Modification Report

MOD 2 Section 4.55(2) to modify
consent SSD-15788005

163 Barry Way, Jindabyne

PREPARED FOR NSW DEPARTMENT OF EDUCATION

FIGURE 2: PROPOSED SIGNAGE ON THE WESTERN FRONTAGE OF BLOCK A

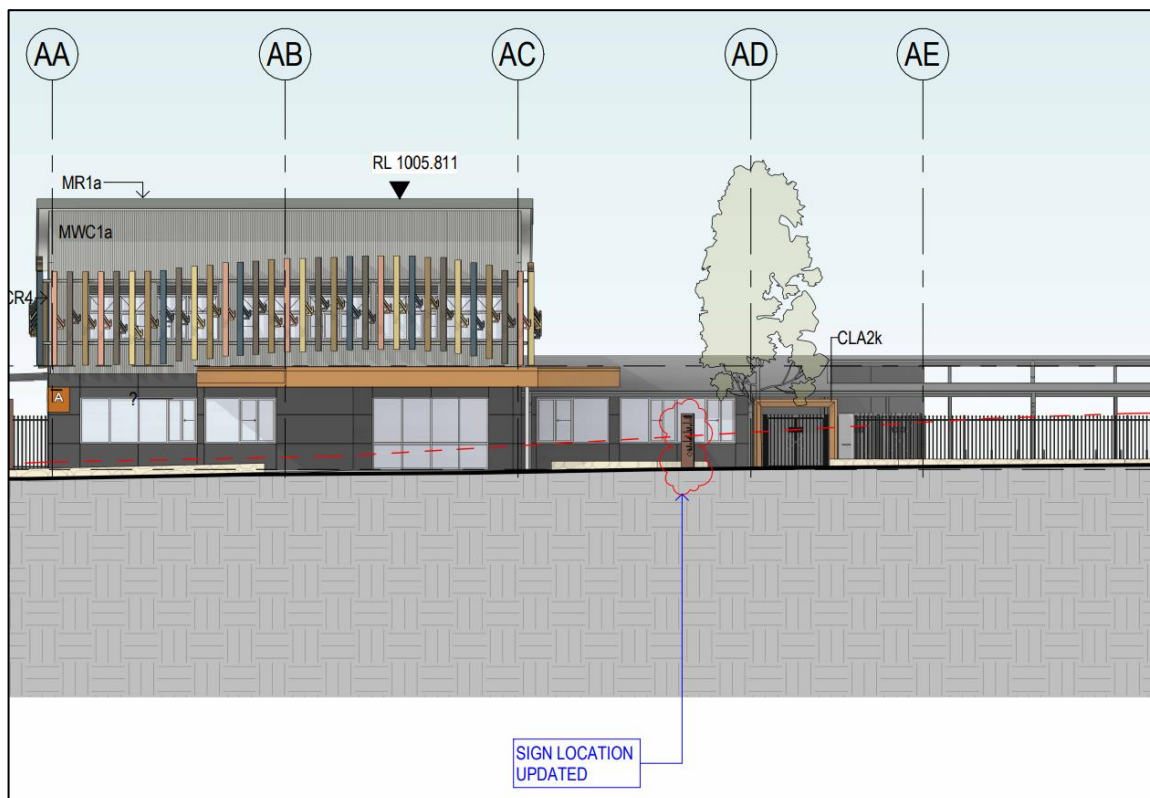
- The wayfinding sign is proposed to be repositioned for better visibility at the western frontage of Block A.

FIGURE 3: SITE ENTRY NORTH

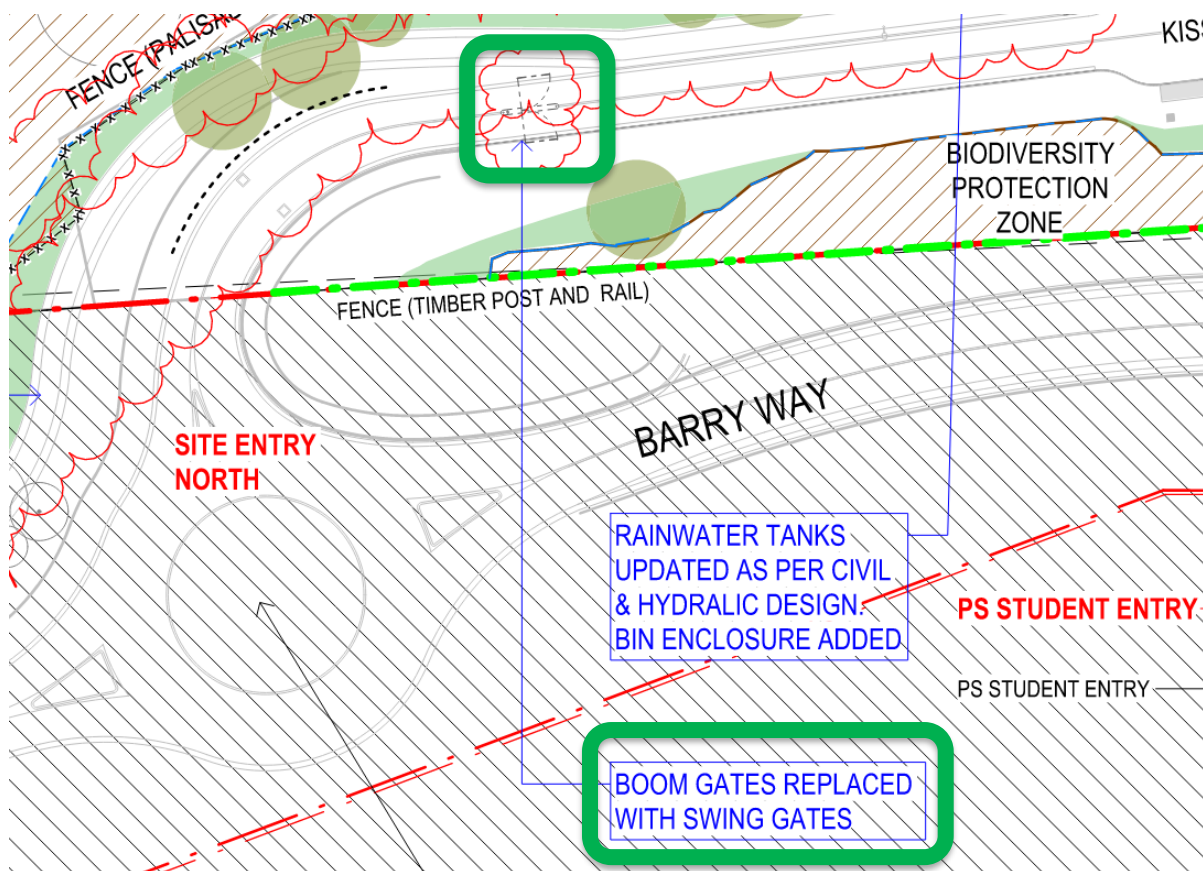
- **Northern Driveway Access:** The approved boom gates are proposed to be replaced with swing gates to facilitate smoother entry and exit onto Barry Way, increase functionality of the kiss and drop function, and enhance access control.
- **Southern Driveway Access:** Similarly, swing gates have replaced boom gates, enhancing the functionality and access control of the driveway.
- **Pedestrian Pathway:** The addition of a pedestrian pathway connecting the Jindabyne Education Campus to Barry Way to facilitate active transportation opportunities for students and staff.

FIGURE 6: PROPOSED MAIN SHED EXPANSION AND PENS

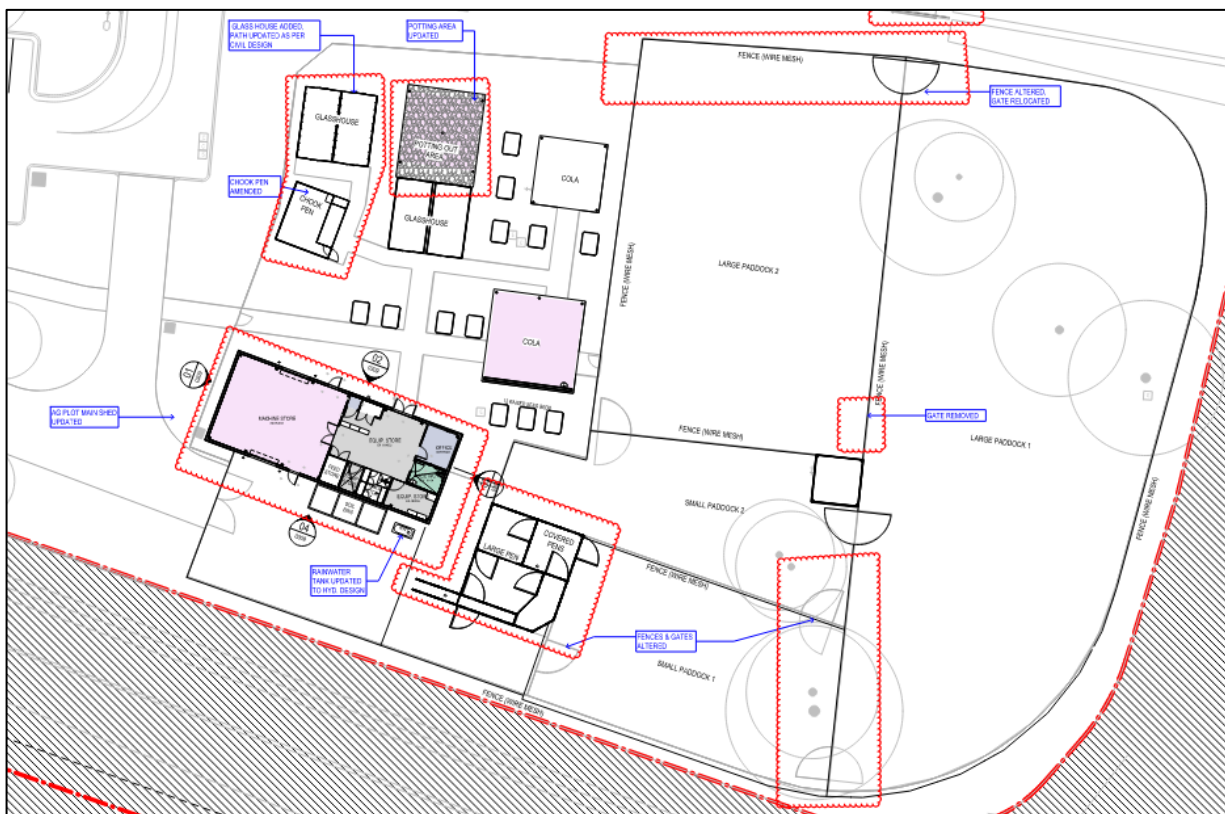
- The large and covered pens have been redesigned for functionality.
- Modifications to the fencing and gates are proposed to ensure better movement between the various paddocks: Small Paddock 1, Small Paddock 2, Large Paddock 1, and Large Paddock 2.
- A new glasshouse and amended pedestrian path are proposed, providing a suitable environment for plant cultivation and education.
- The Agriculture Plot's main shed is proposed to be expanded to increase its machine storage capacity and to include an accessible bathroom to accommodate all students. This results in an enlarged building footprint. Detailed design has resulted in external design changes including a smaller and realigned roller door, the addition of windows and vents, and minor changes to the building height. A 2kL rainwater tank is provided to capture stormwater from the roof.

FIGURE 8: SHARED PLAZA AMENDMENTS (EASTERN FAÇADE)

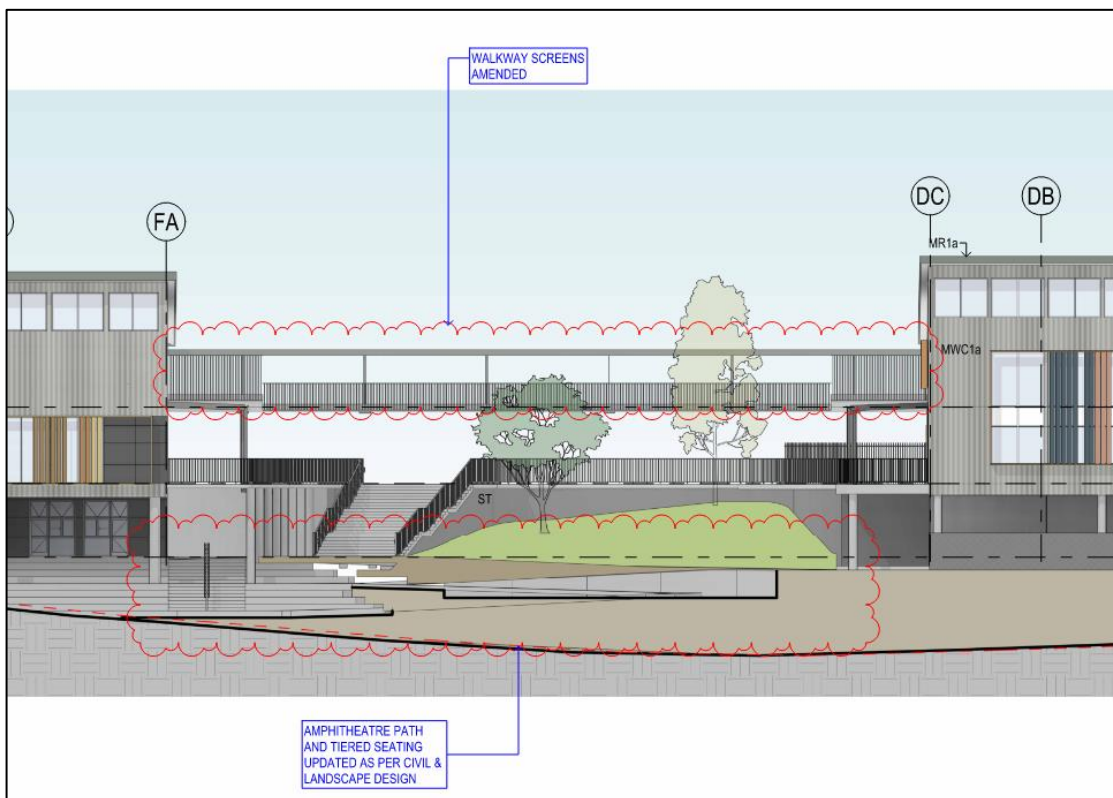
- The amphitheatre's path and seating have been redesigned to improve functionality, pedestrian access, and integration with the natural topography.
- Between Blocks F and D, the walkway façade has been amended to include screens to increase function and aesthetics.

FIGURE 9: OPEN SPACE AMENDMENTS BETWEEN BLOCKS B & C

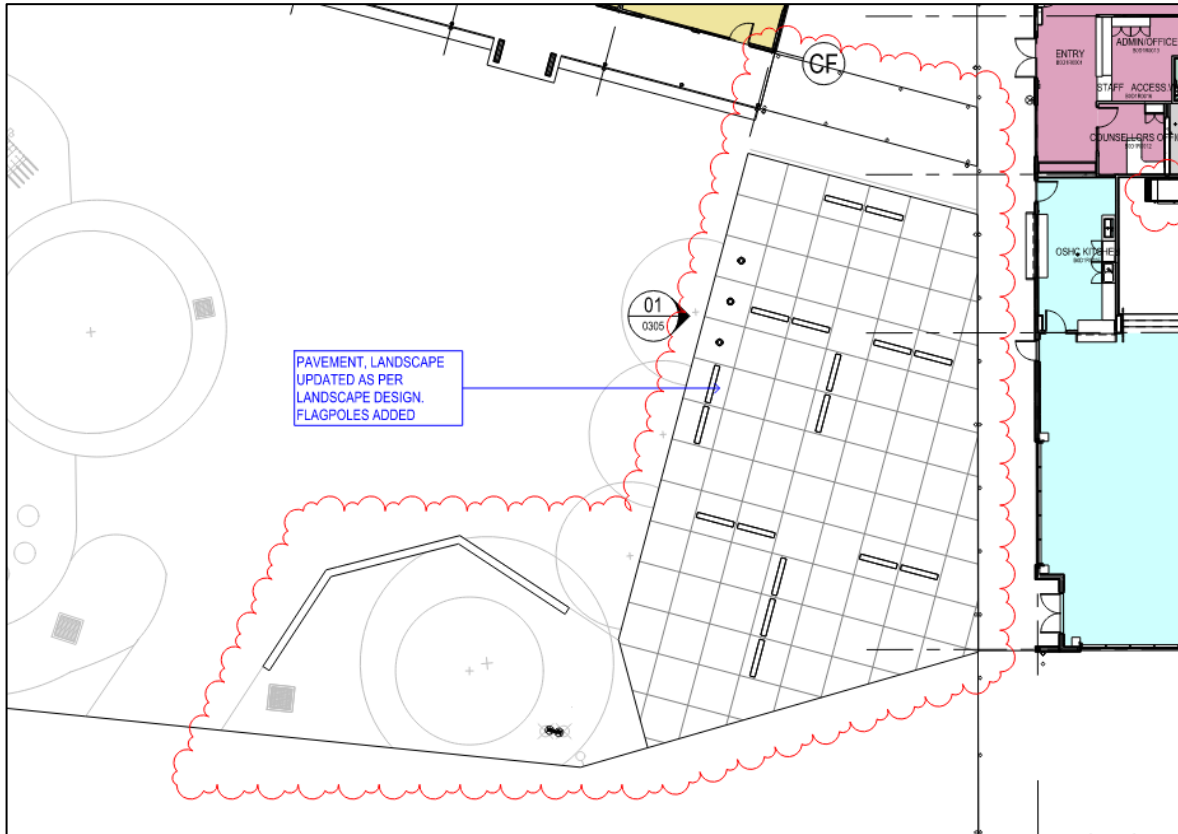
- Aluminum bench seating is proposed to replace the existing handball courts to provide a more flexible use of the paved area.
- The addition of three flagpoles is proposed.
- Minor amendments are proposed to the location of the stone wall to respond to the updated landscape and civil design.

FIGURE 10: PROPOSED OPEN SPACE BETWEEN BLOCK F AND G

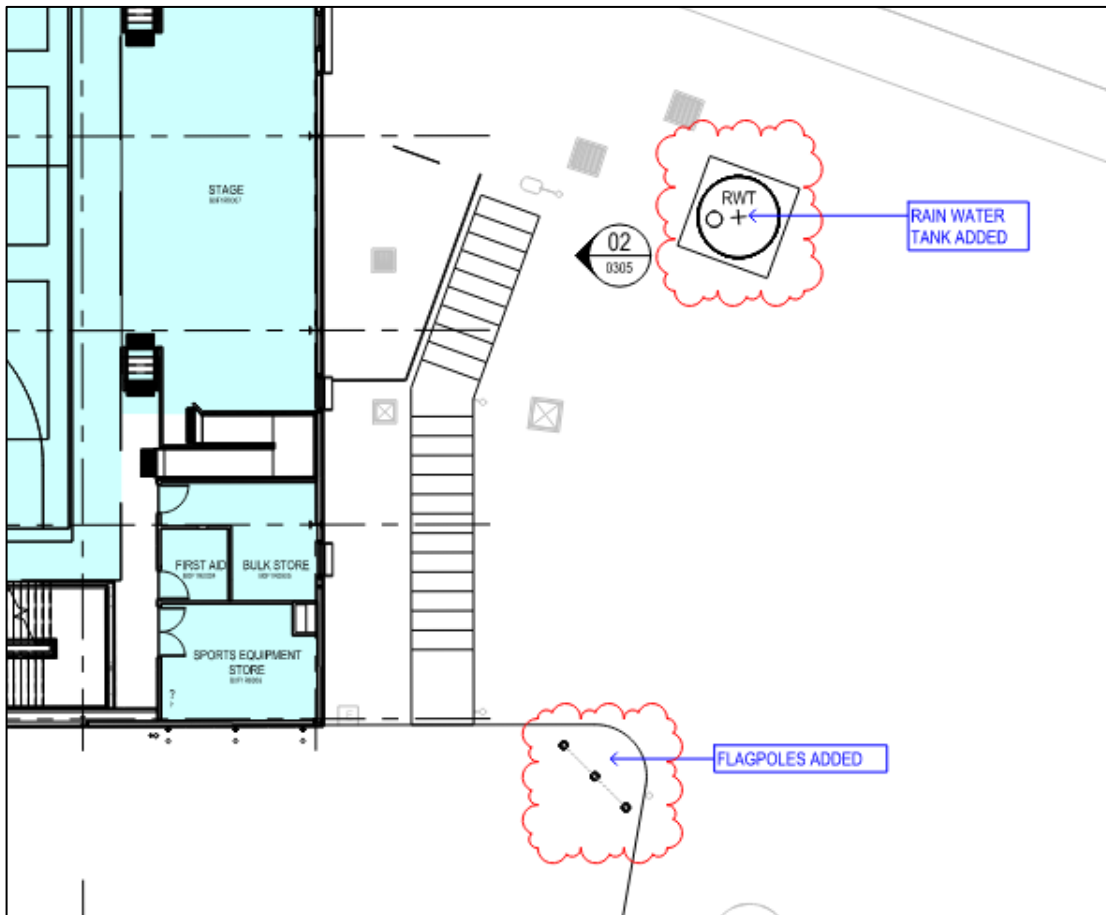
- Installation of aluminum bench seating to the east of Block A.
- Amendments are proposed for the stone wall and landscaping south and west of Block E and the addition of three flagpoles between Block F and Block G1.
- A new rainwater tank is proposed to the east of Block F, in accordance with the civil and hydraulic design updates.

FIGURE 12: BLOCK B AMENDMENTS (WESTERN FAÇADE)

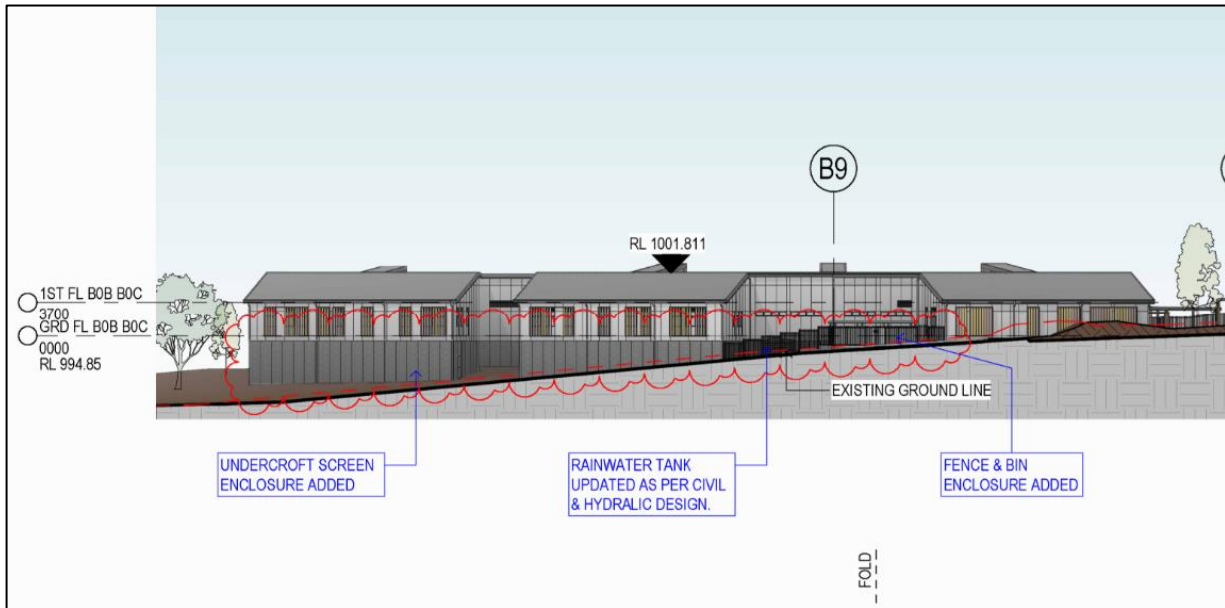
- A new rainwater tank is proposed between Blocks B2 and B1.
- A new bin enclosure is also proposed for improved waste screening.
- An undercroft fence is proposed to be added to Building B.

FIGURE 14: BLOCK C AMENDMENTS (EASTERN FAÇADE)

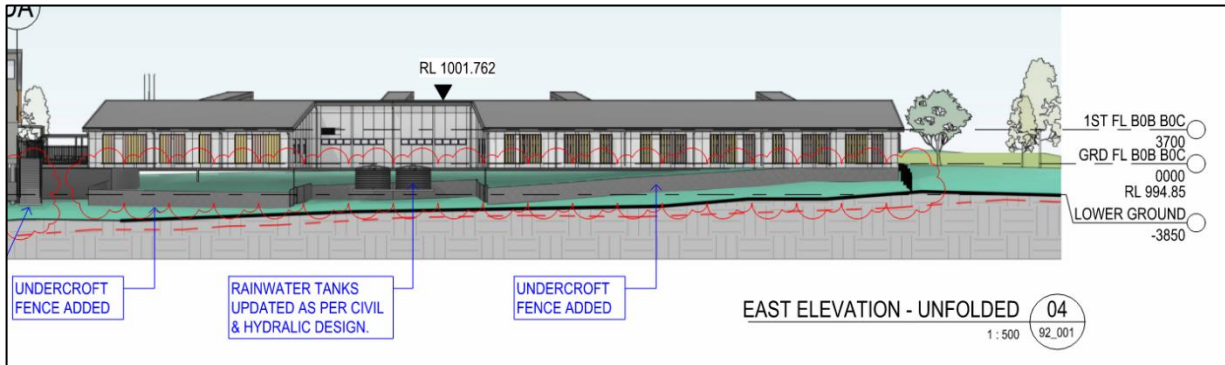
- Two new rainwater tanks are proposed between Blocks C2 and C1, to accommodate the civil and hydraulic design updates.
- An undercroft fence is proposed to be added to the building for increased student safety and access control.

FIGURE 15: NORTHERN ELEVATION OF BLOCK D

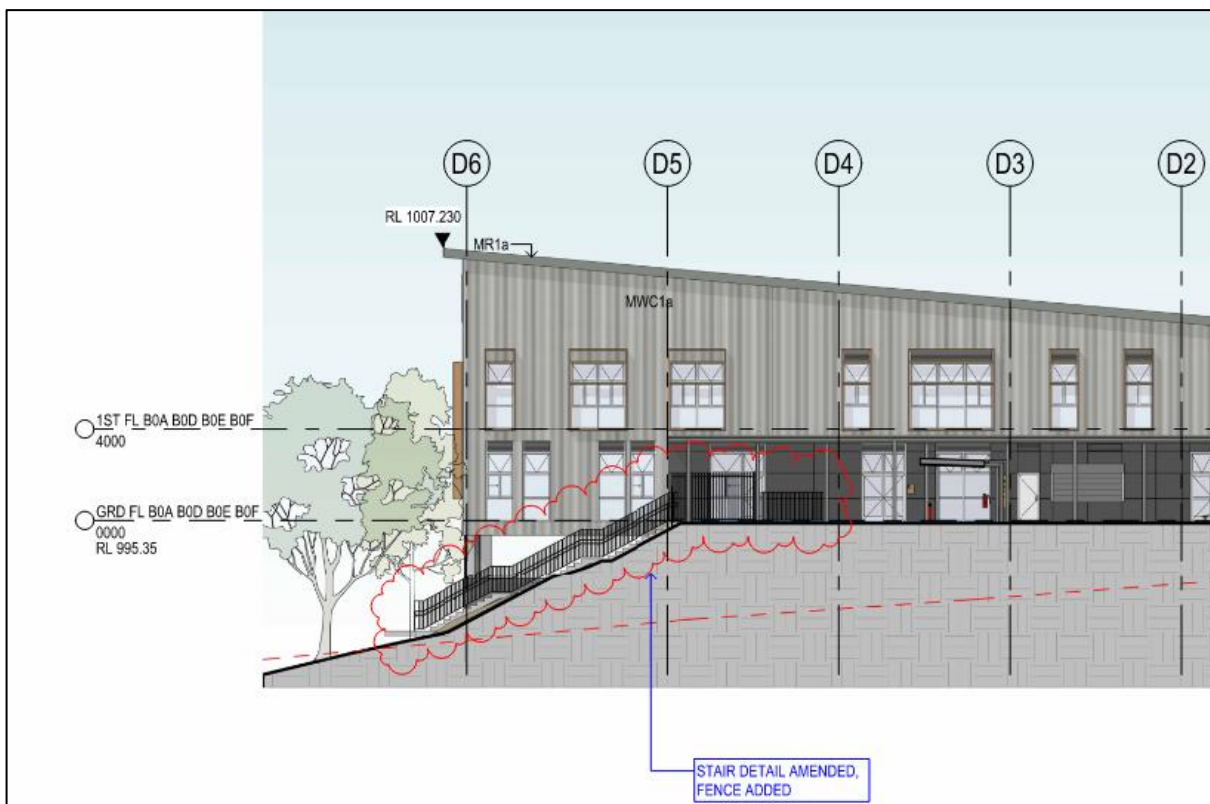
- New fencing to be added along the northern façade for improved access control.
- Inclusion of detailed stair design and additional fencing on the eastern façade.
- Minor revisions to the mechanical plant area and inclusion of screens in the walkway façade between Blocks D and A for enhanced functionality and appearance.
- Minor increase (from RL 1007.230 to RL 1007.233) in building height to suit detailed design requirements.
- Minor changes to the external façade including amendments to windows and vents as well as changes to the proposed stone wall and retaining wall to suit detailed civil design.

FIGURE 18: PROPOSED BLOCK E PLAN

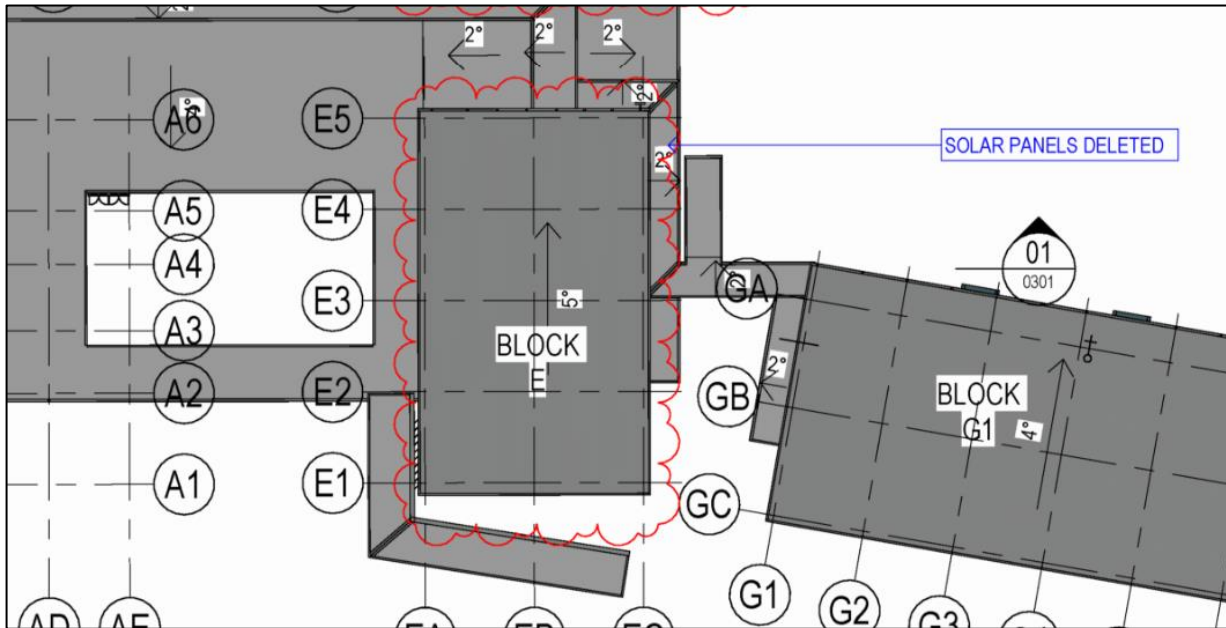
- The proposed solar panels have been removed from the Block E roof (refer to detail provided in Section 2.1.12 of this report).
- Minor modifications have been made to the walkway facade between Blocks E and F integrating new screens.

FIGURE 20: PROPOSED SOLAR PANEL LAYOUT AT BLOCK F

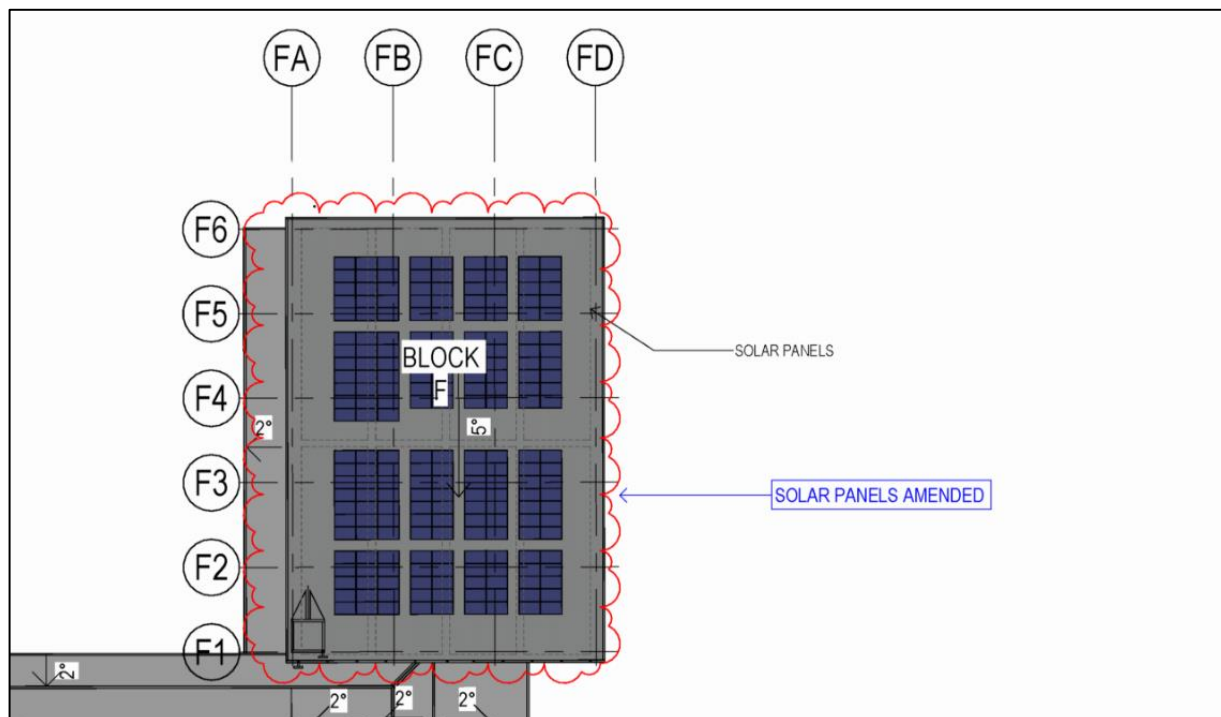
- The configuration of solar panels on Block F is proposed to be modified to increase the efficient integration with the roof.

The originally proposed solar panel design included two separate systems with solar panels on both Blocks E and F to accommodate a maximum output of 99.9kW to meet the relevant Education Facilities Standards and Guidelines (**EFSG**) requirements. The revised solar panel design delivers the same output on a single system. As such, the proposal maintains the ability to achieve the minimum 4-star Green Star rating with the Green Building Council of Australia as required under Condition B10 of the consent.
